S E R V I C E N O T E

E4401B, E4402B, E4403B, E4404B, E4405B, E4407B, E4408B, and E4411B ESA Spectrum Analyzer family. Also E7401A, E7402A, E7403A, E7404A, and E7405A EMC Pre-Compliance Analyzers.

Intermittent screen "flicker" due to a cold solder joint

DATE: January 2001

Figure 1

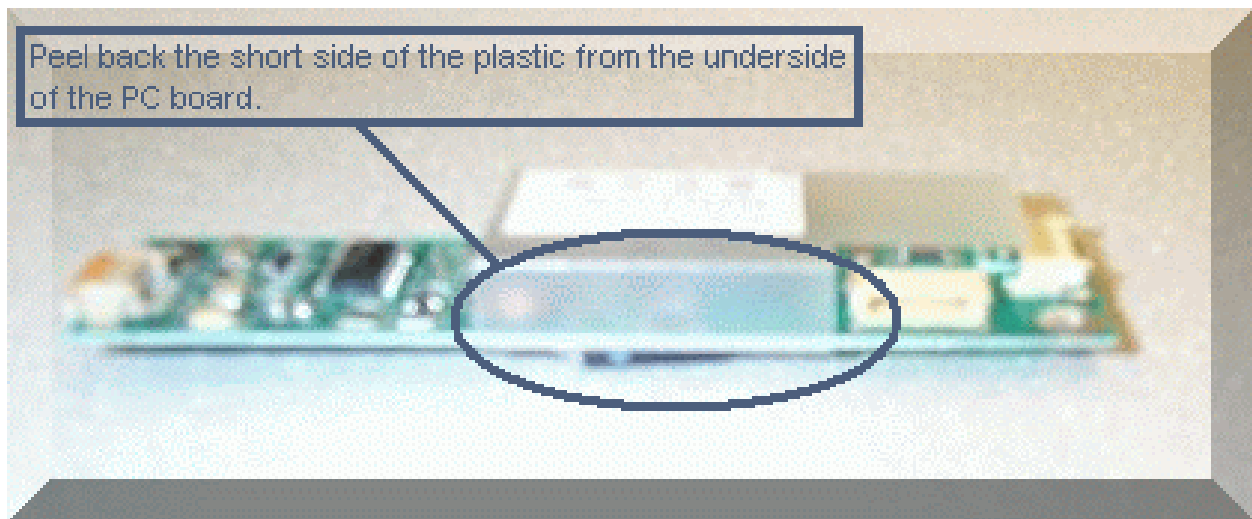
- 1) Peel back the plastic shield on the backlight inverter board. See Figure 1.

Figure 2

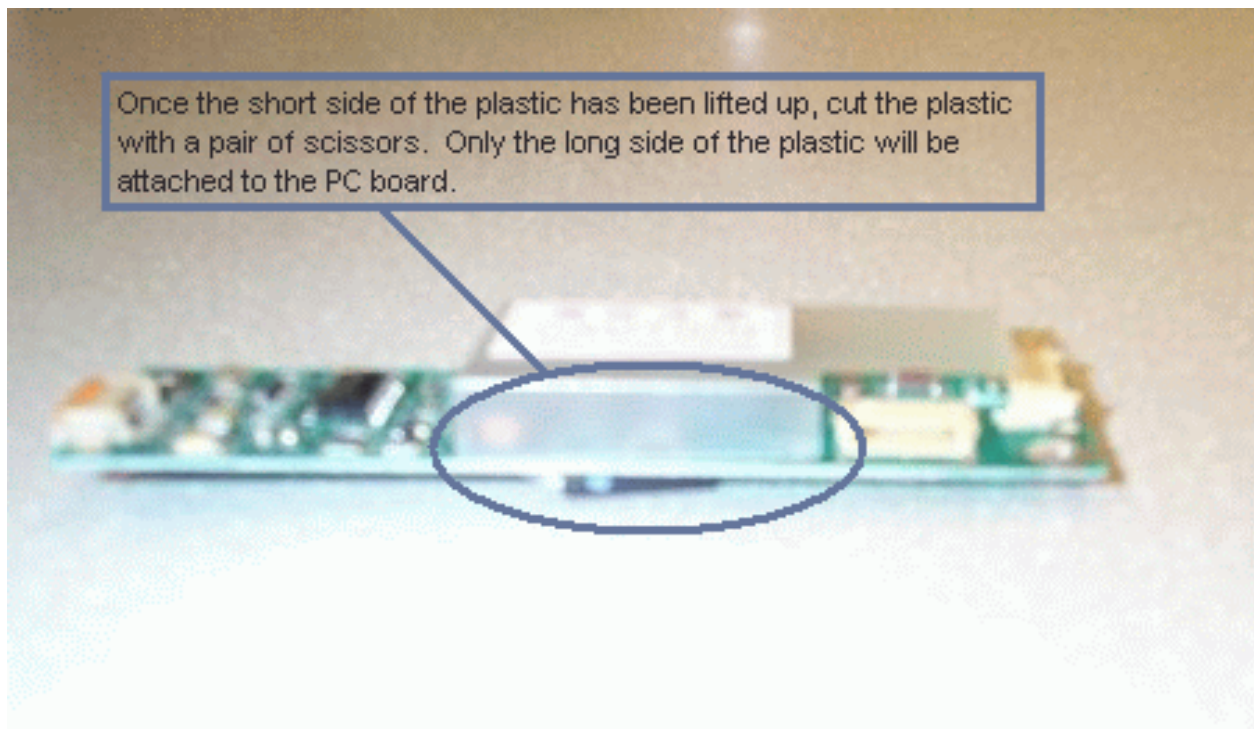
- 2) Cut the plastic with a pair of scissors. See Figure 2.

Figure 3

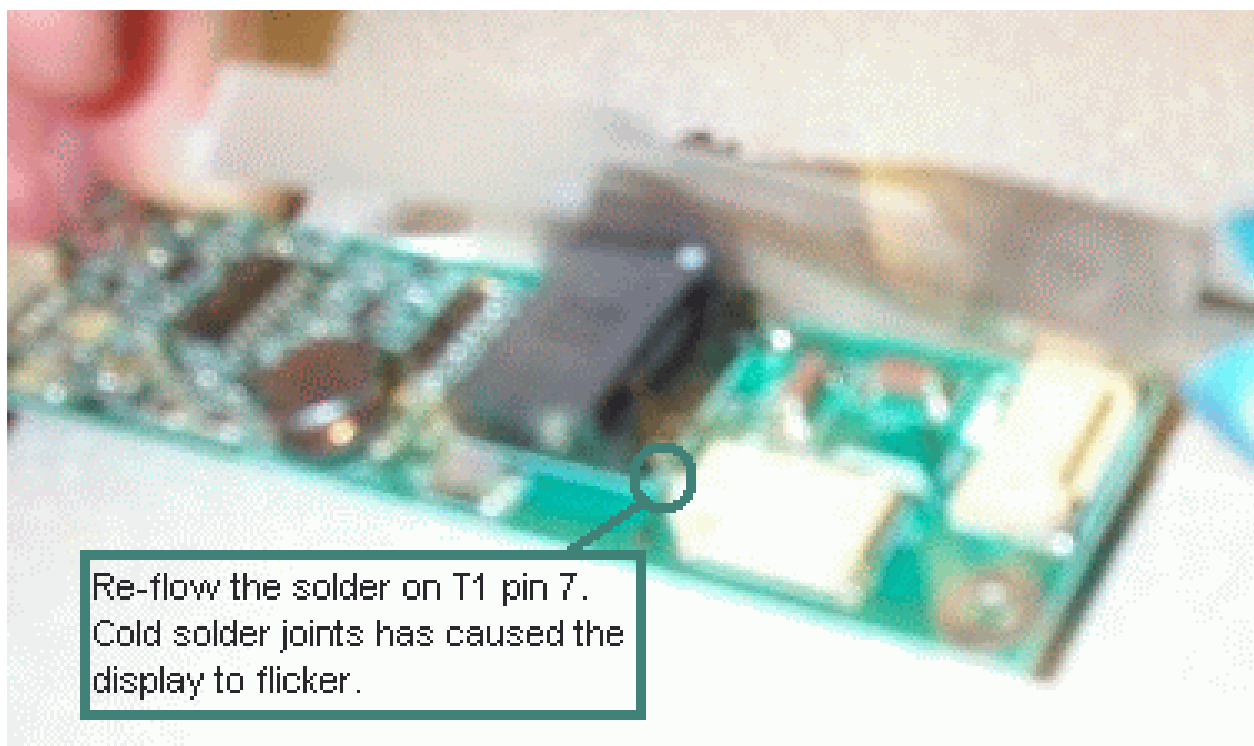
3) Re-solder pin 7 of the transformer on the backlight inverter board. See Figure 3.
